LAND USE BOARD APPLICATION

FOR OFFICIAL USE	ck xxx 9857	MP	
Date Rec'd: <u>8/21/2024</u>	Application #: <u>LB24-05</u>	Fee: <u>\$350</u>	Escrow: <u>\$750</u>

McGHEE RESIDENCE

43 Gravelly Point Road
Highlands, NJ

NOTE: ALL SIDING SHALL BE FIBR BOARD AND BATTEN BY JAMES HARDIE, INC. COLOR AS SELECTED BY OWNER, TYP. ALL ELEVATIONS. DETAILS SHALL BE BY MANUFACTURER'S SPECIFICATION AND INSTALLATION RECOMMENDATIONS.

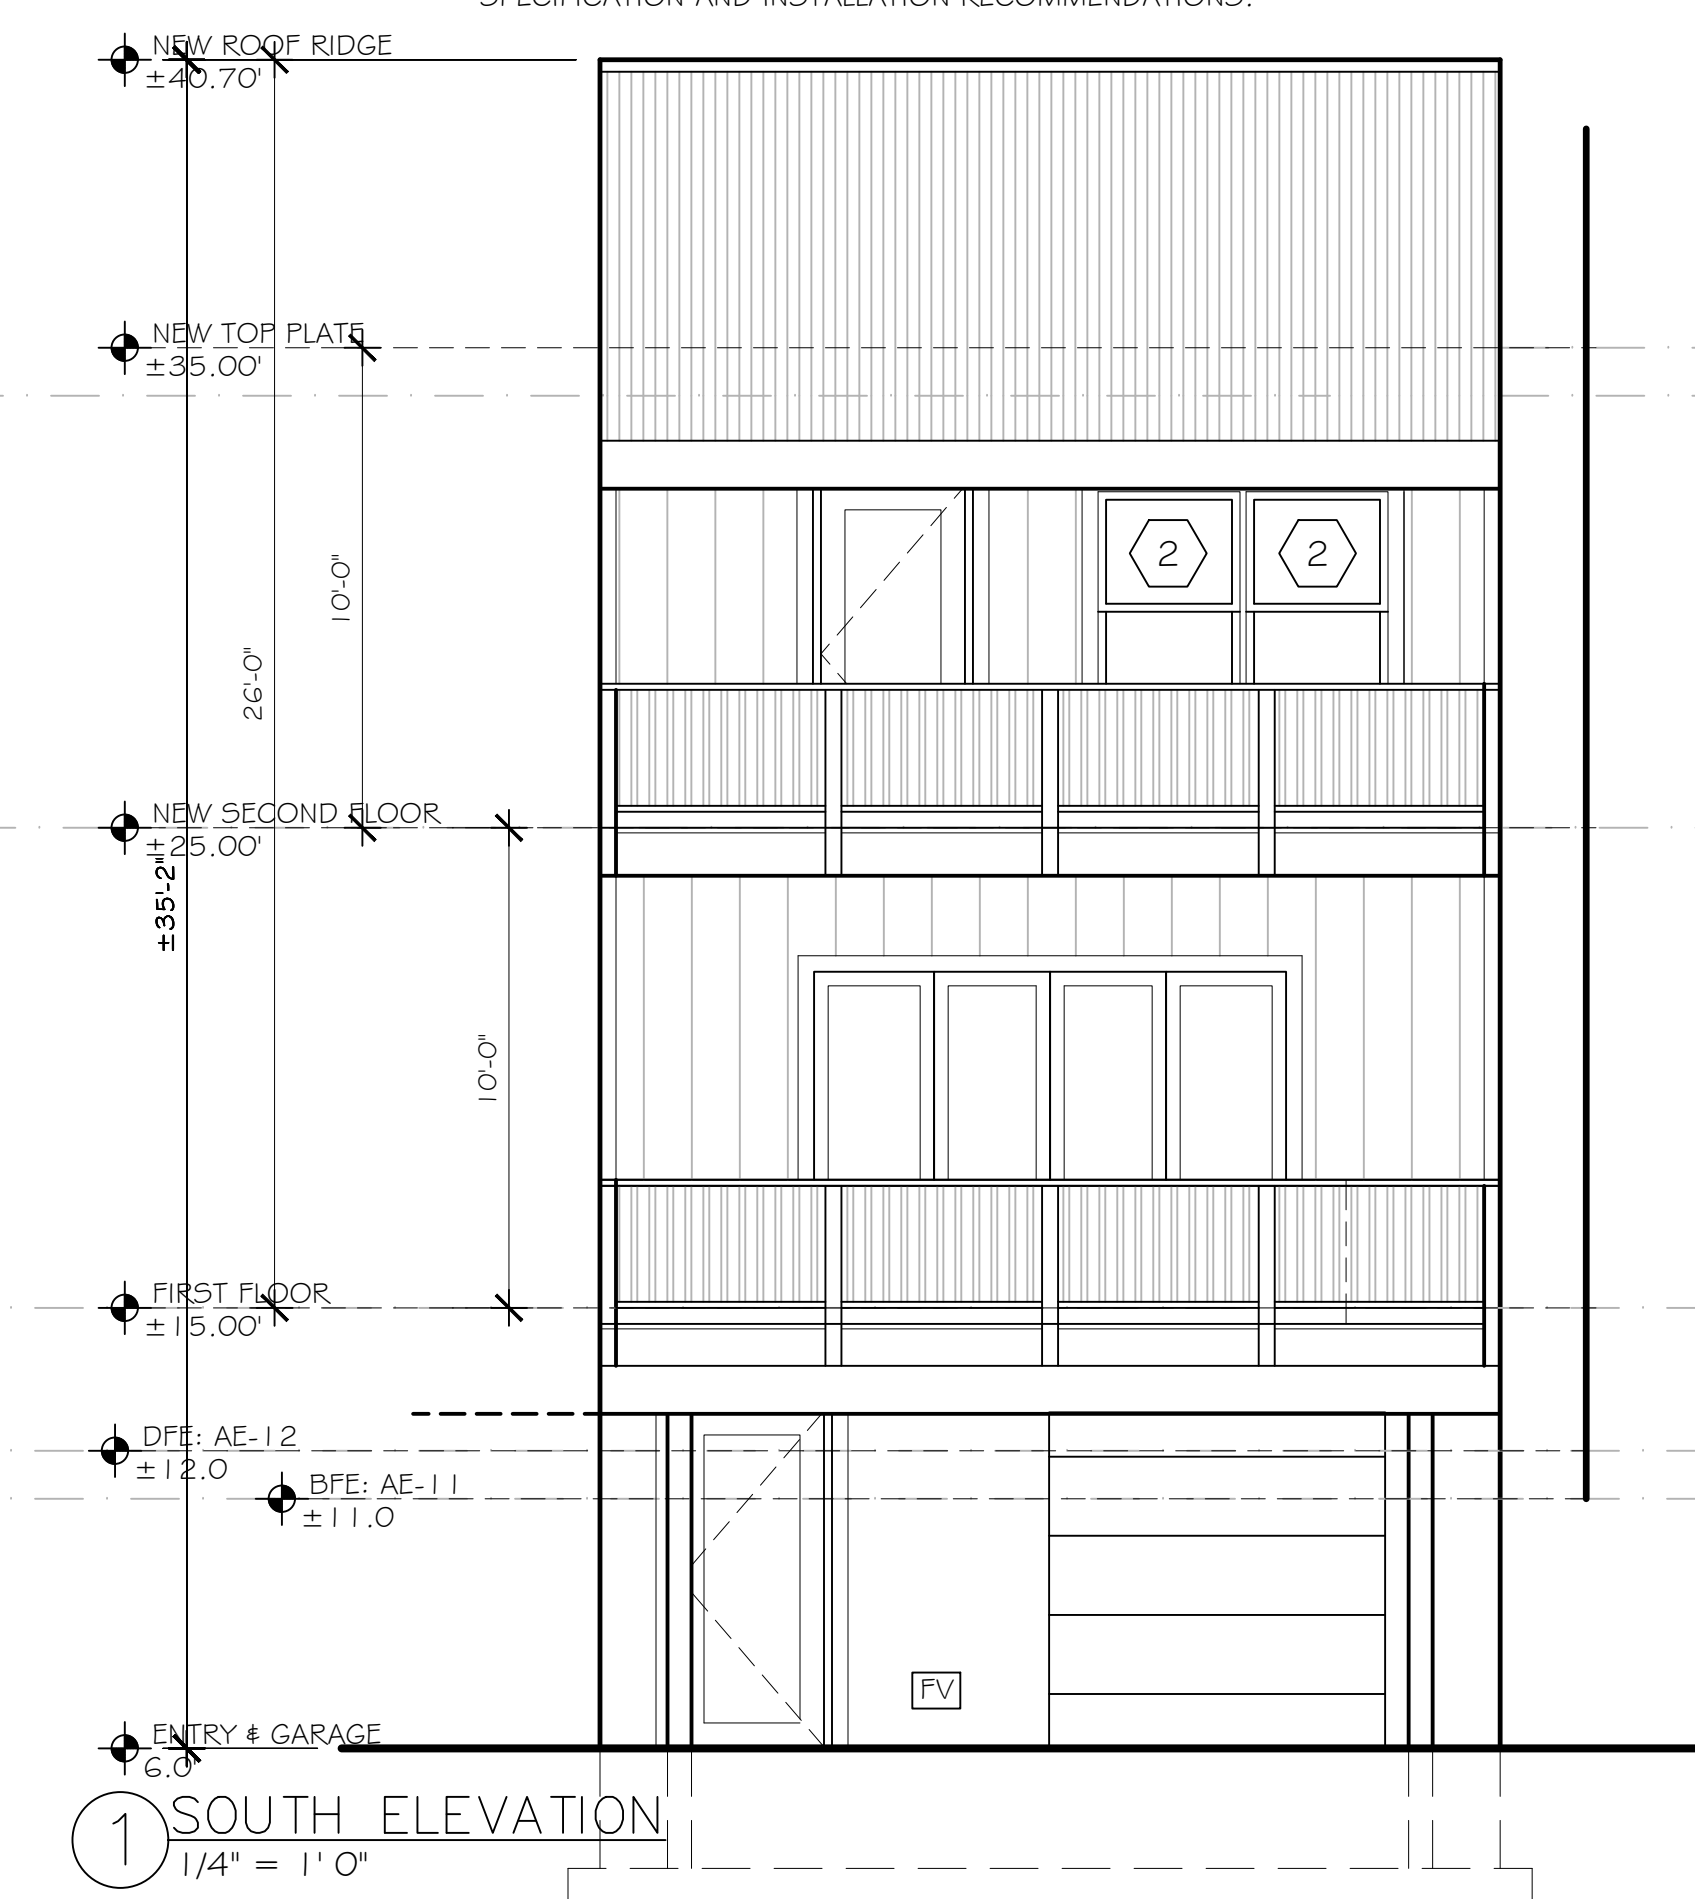
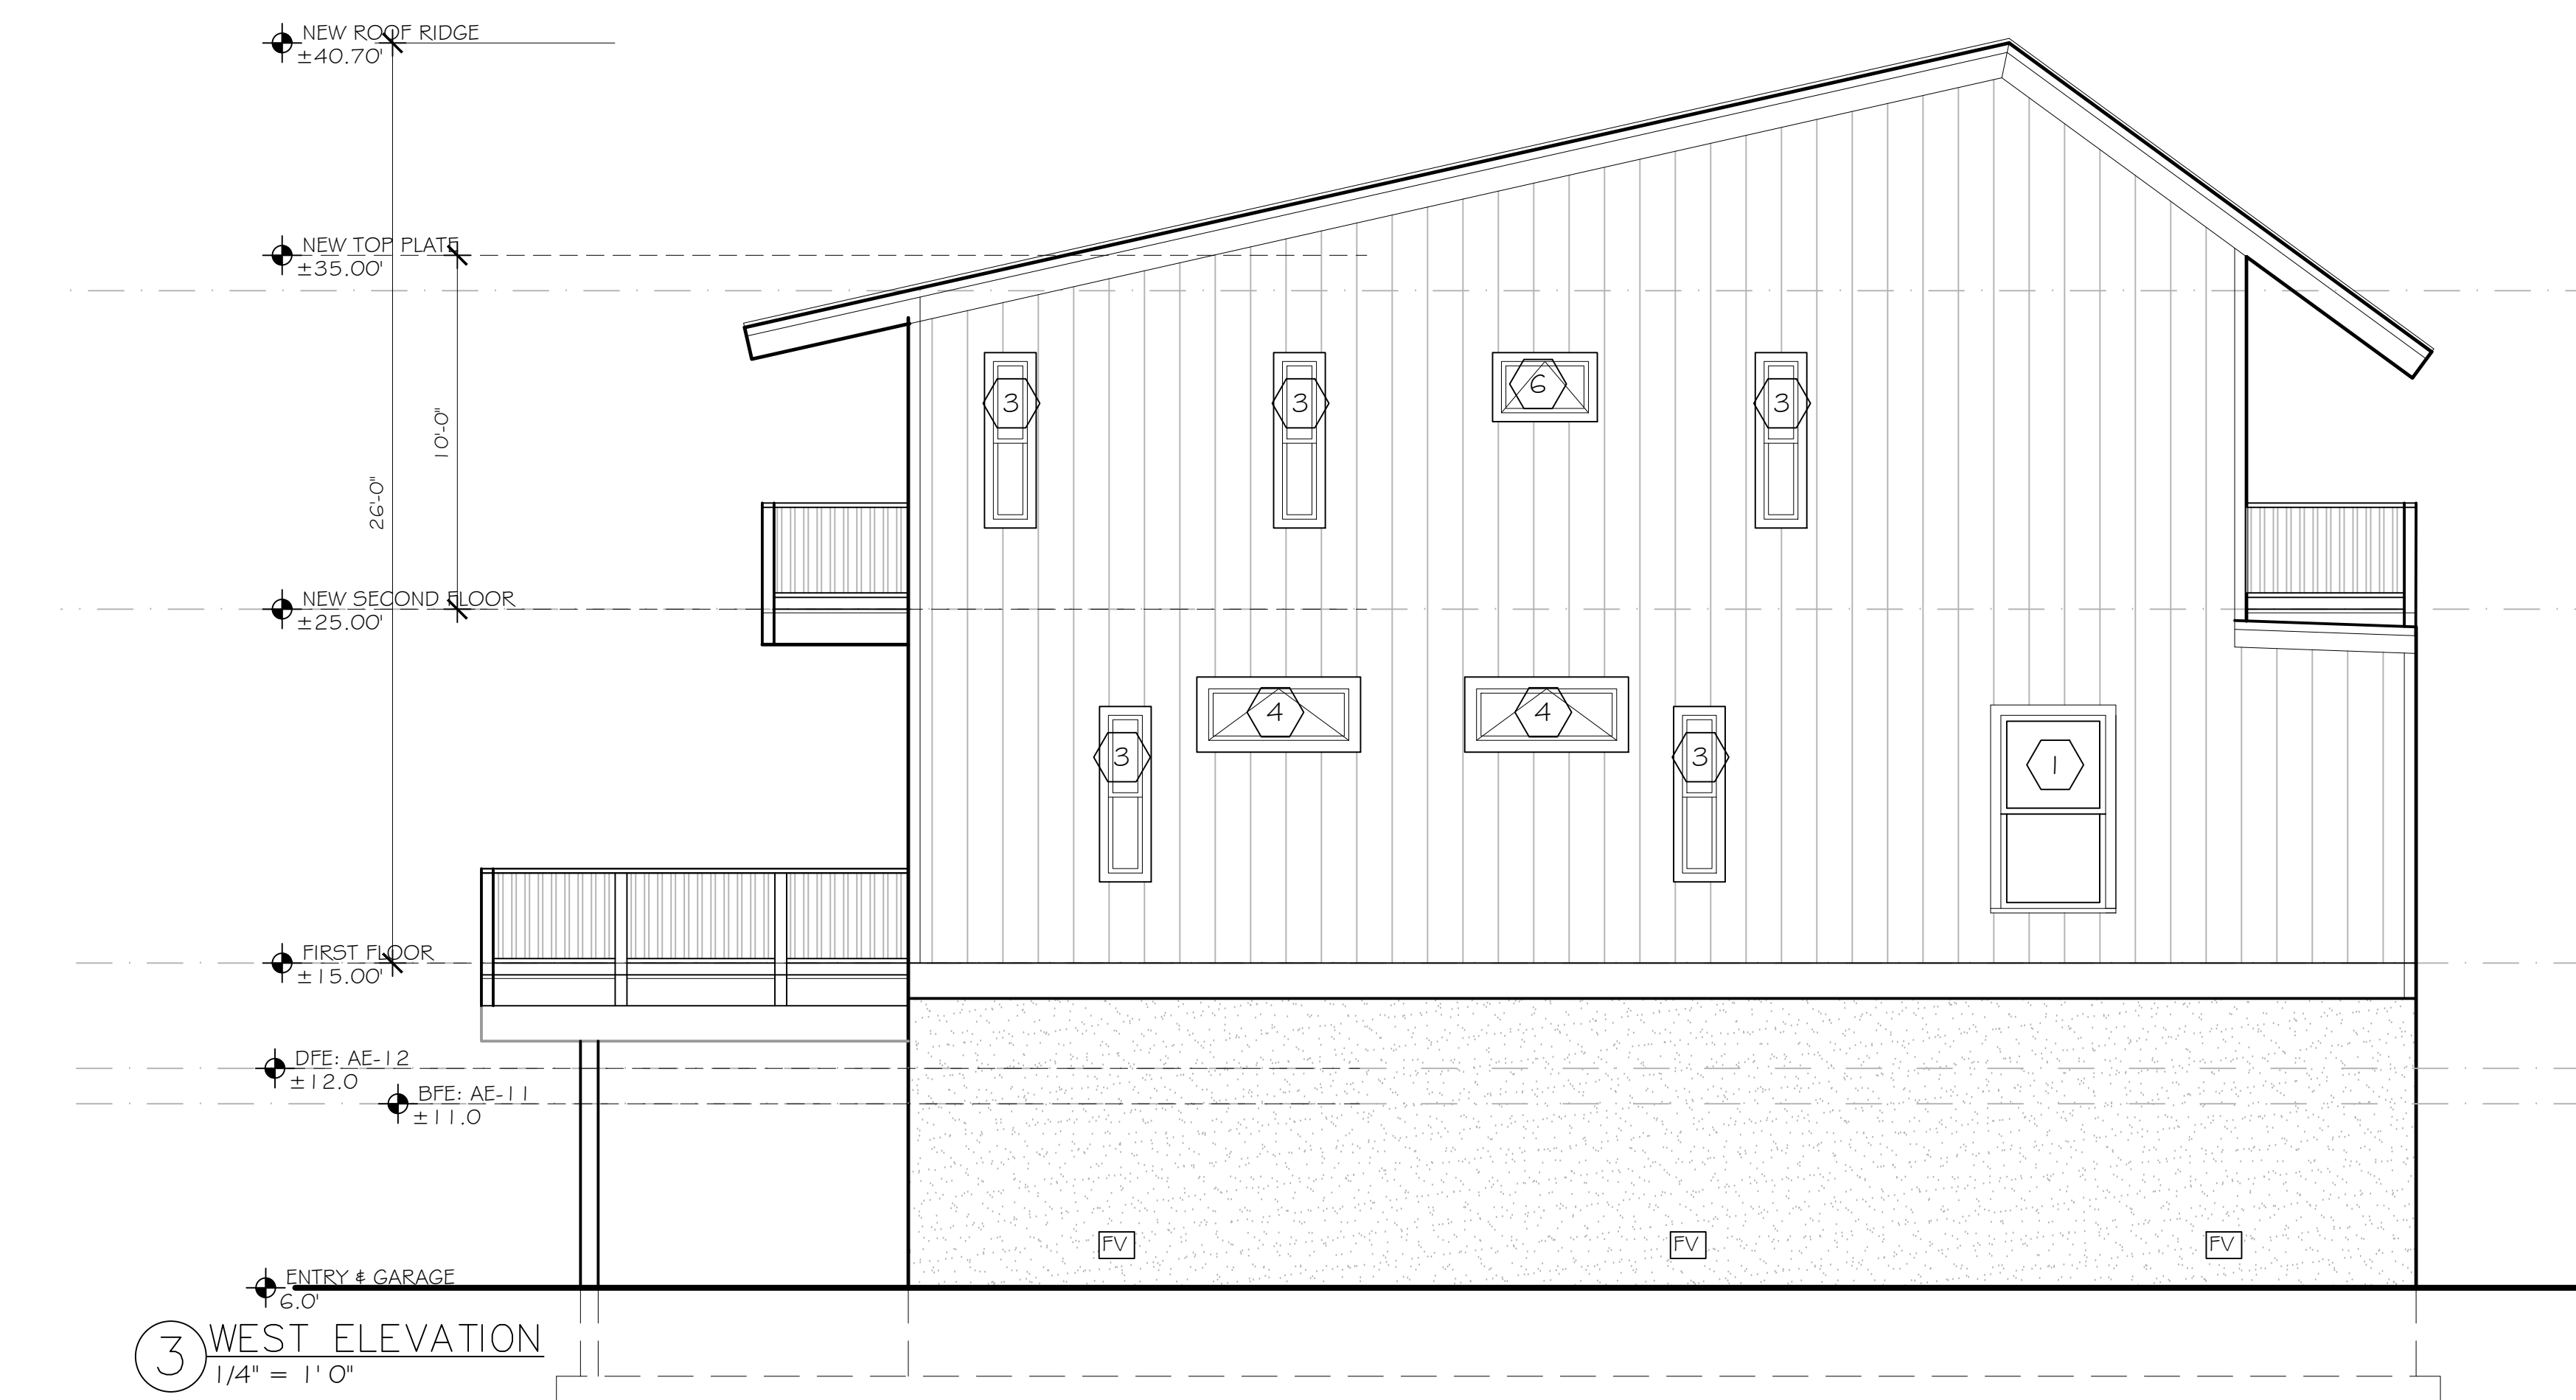
The building height is incorrectly shown on the architectural plans.

Please update the maximum building height based on §21-8 Definitions for Building Height and Grade Plane shown on the Exterior Elevations. One foot is to be added to the BFE within the Flood Hazard Area. In the case of sloped roofs, the average height is the mid-point between the lowest roof eave of the top floor and the roof ridge.
